### Development Team Review Comments

**Case Name/ Number:** VSP2025-00034 Fabrizio Acres Setback Variance

**Re: Fabrizio Acres Variance Request**  
**Response to Comments Issued 09-08-2025**

Project: **Fabrizio Acres Setback Variance**  
Address: **2521 East 68<sup>th</sup> Place**  
Reviewed By: **Carla Gutierrez**

# SITE PLAN FOR FABRIZIO ACRES BUSINESS PARK

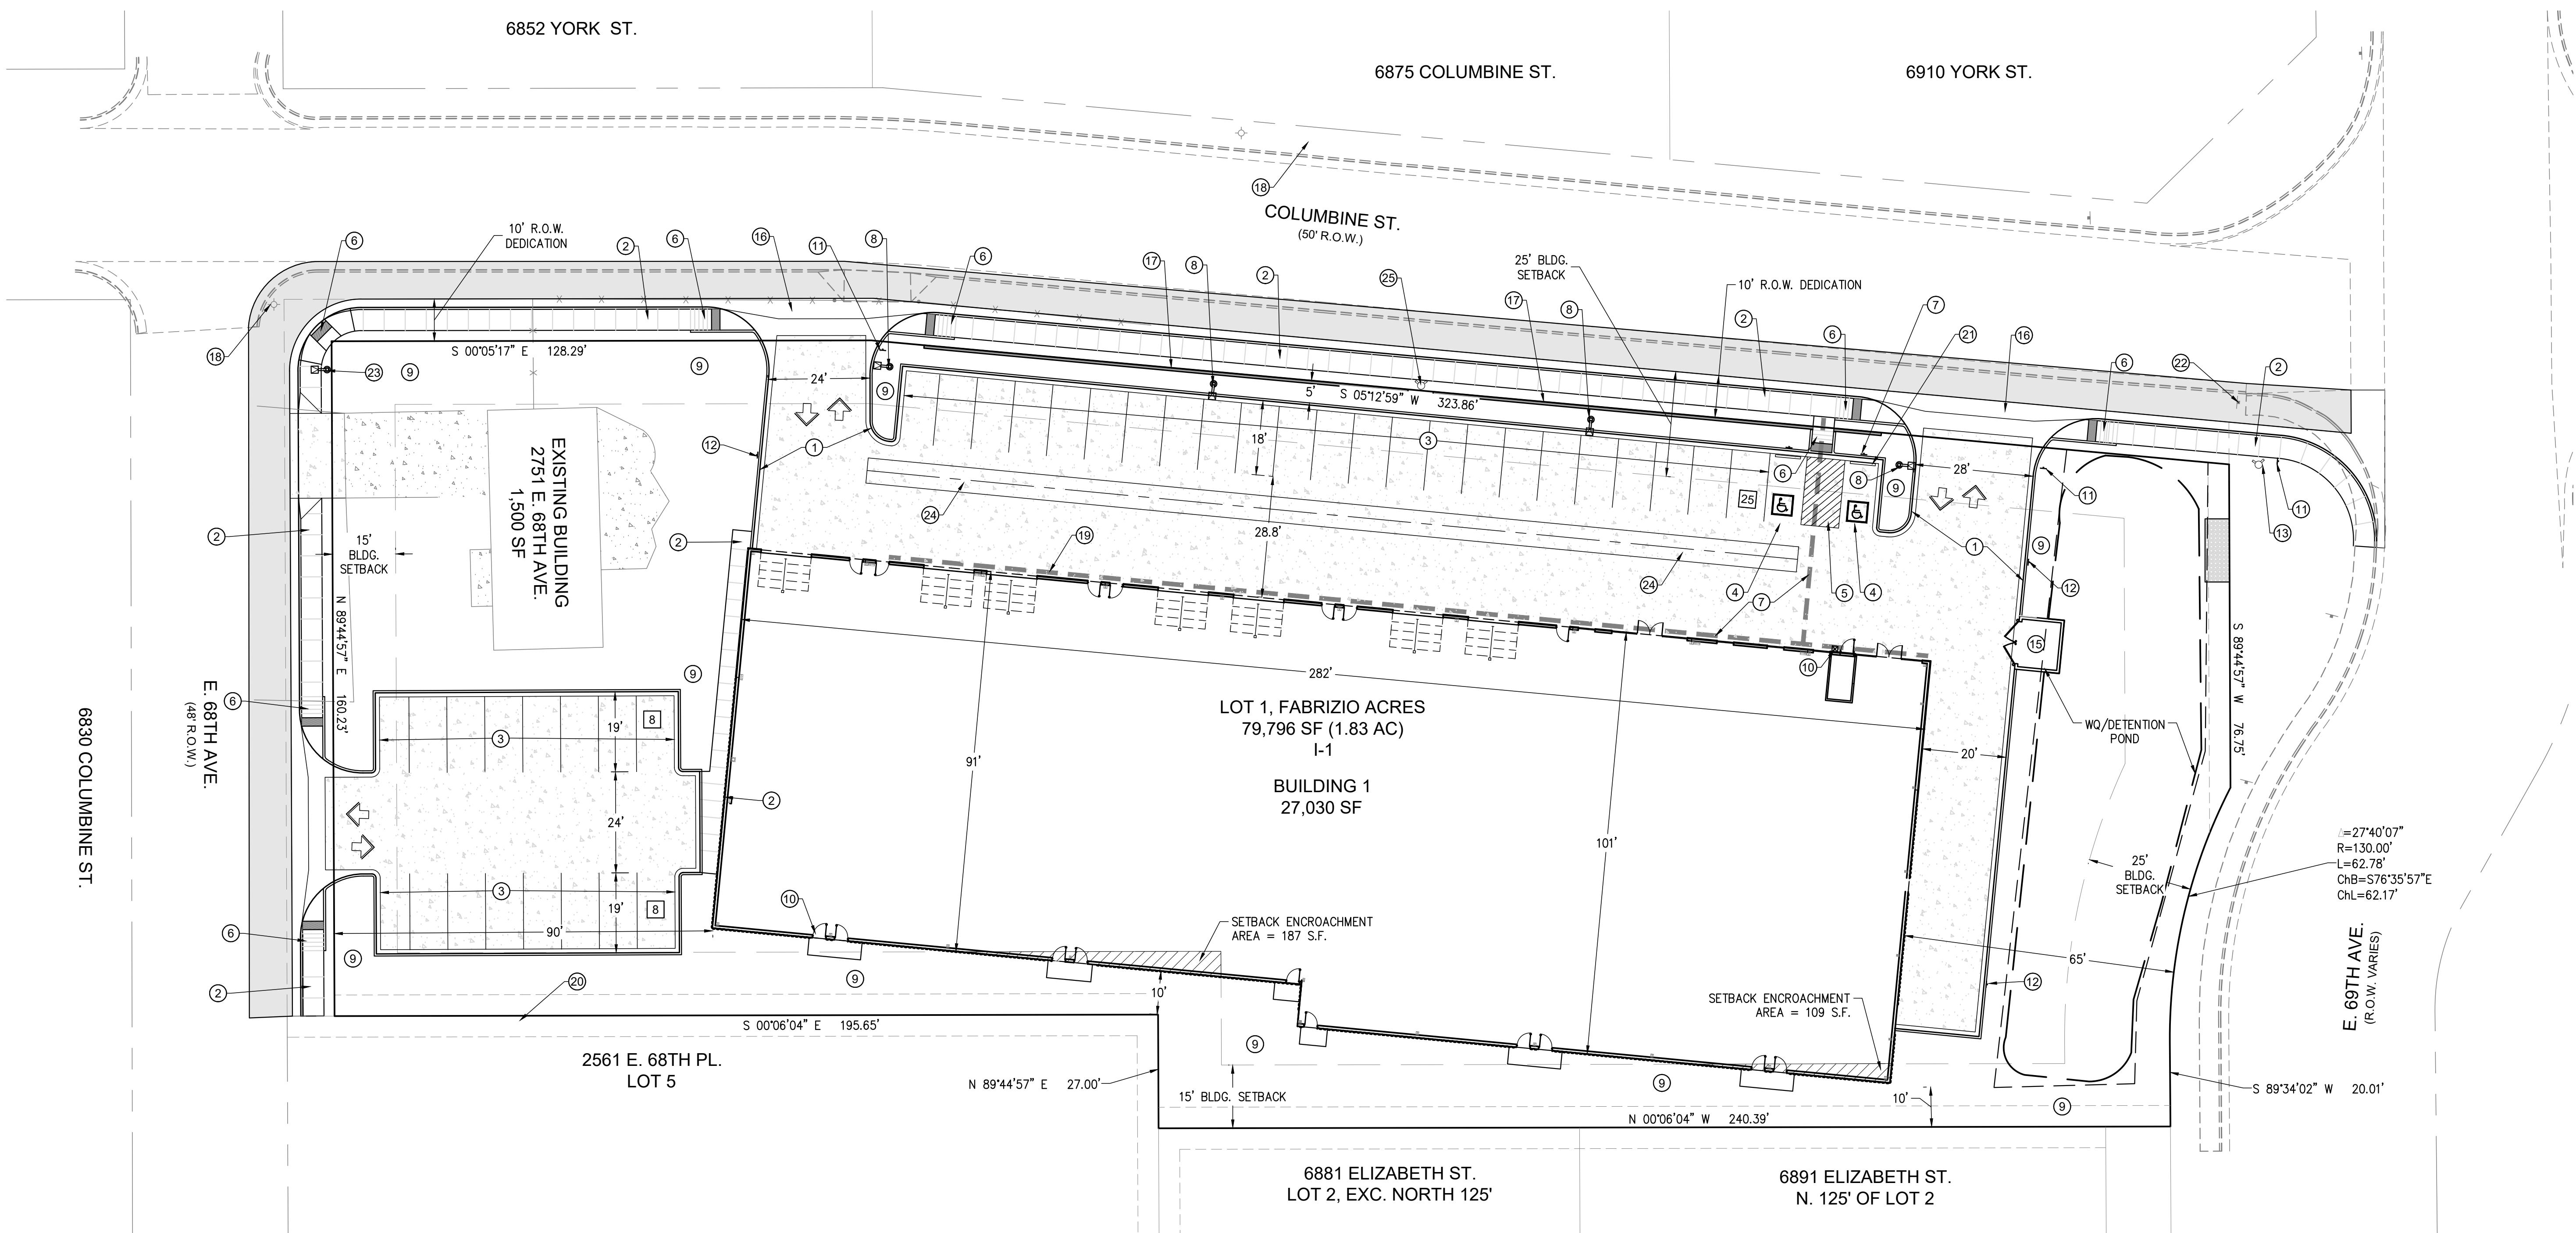
ROW2: The water quality pond shown on the north side of the site plan is encroaching onto the easement reservation created by the ROW vacation of E. 69th Avenue. Applicant must provide evidence of no pipelines or other utilities within the reservation area.

**If the building exceeds 30' in height, an aerial apparatus road will be required. Please advise the height of the proposed building. The proposed fire apparatus access road appears to be 28' in width, this would satisfy the width of the aerial fire apparatus requirements.**

**Not all exterior portions of the proposed building are within 150' of the fire apparatus access road.  
See revised site plan per our discussions which provides access as requested.**

**Unable to verify, no hydrants are shown on the conceptual plan. A utility plan shall be provided to verify hydrant locations.**

*The pond is not encroaching into the ROW easement reservation. Per the attached utility plan which depicts both existing and proposed utilities, we have no evidence of any other utilities in the reservation easement based on utility locates and site survey.*

**The building is less than 30' in height (29'-6" maximum).**

**Please see revised site plan with the two hydrants, one existing and one proposed, shown.**

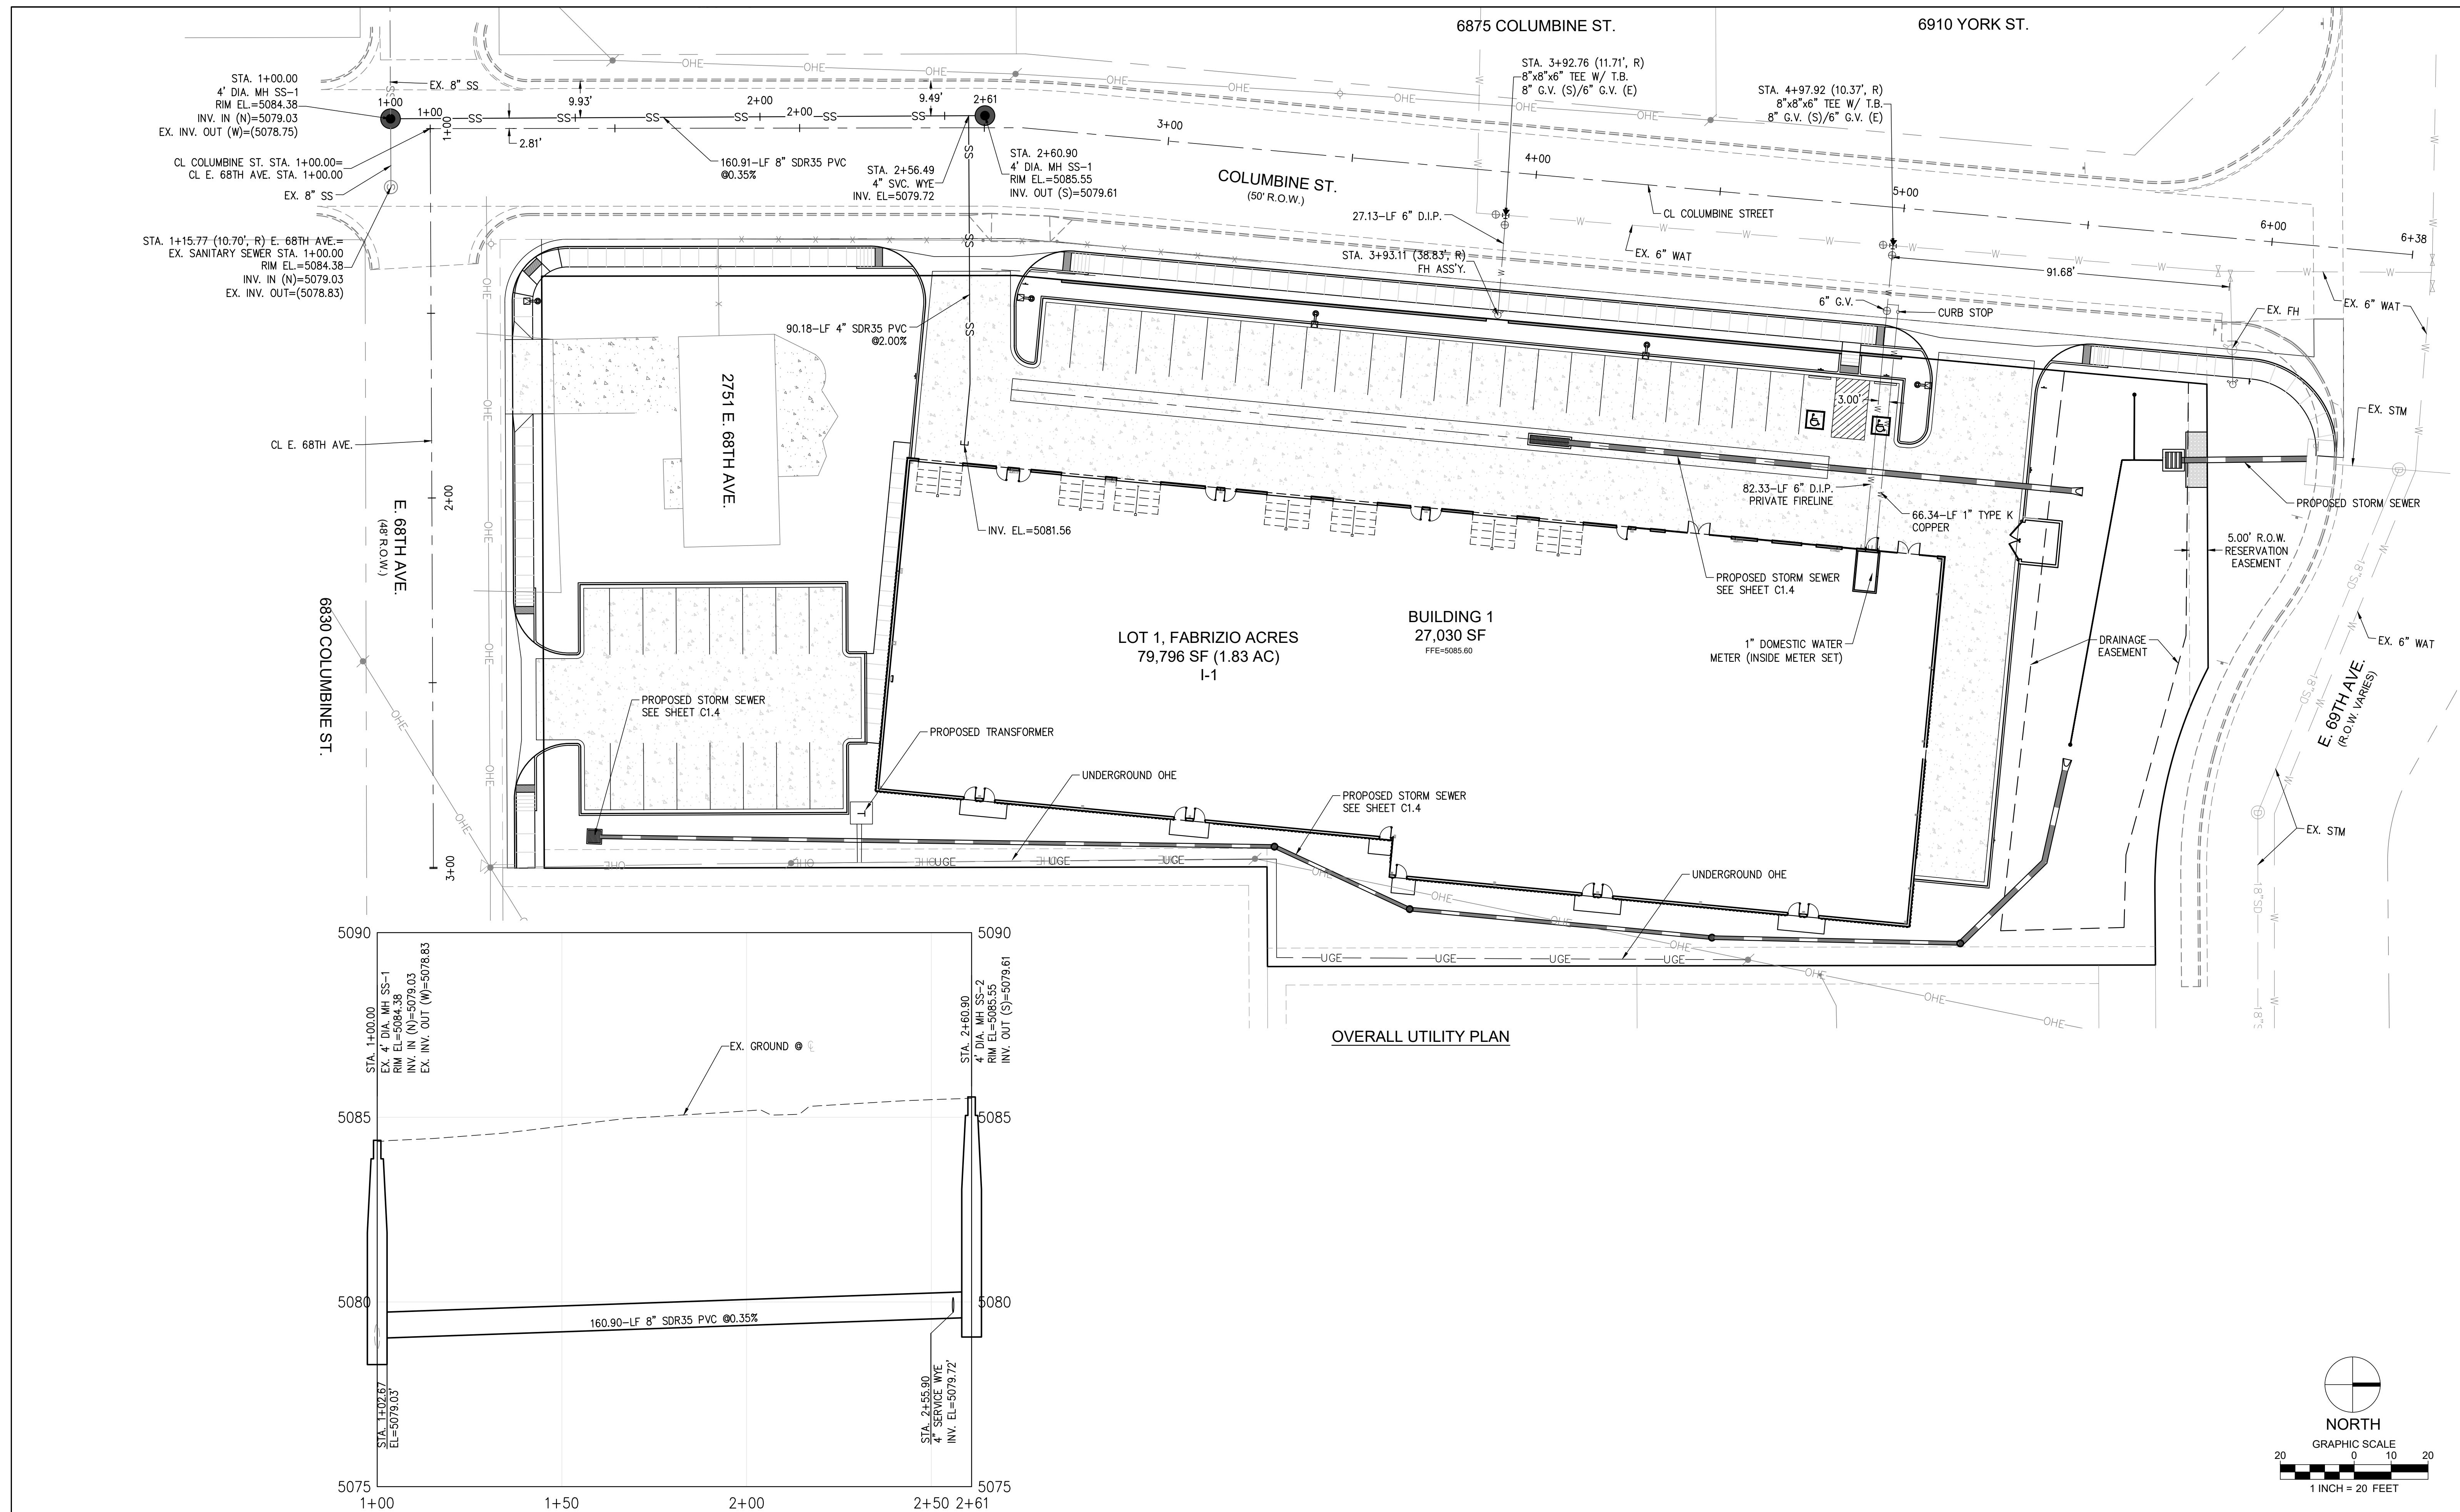
Please see attached the Utility Plan for the Fabrizio Acres project. As you will note, we propose to place part of the overhead electric (OHE) lines underground for a portion of the property along the east property line. There is a portion of the OHE that is outside the platted easement for the property that is the subject line for undergrounding, and will be directly affected by the proposed building.
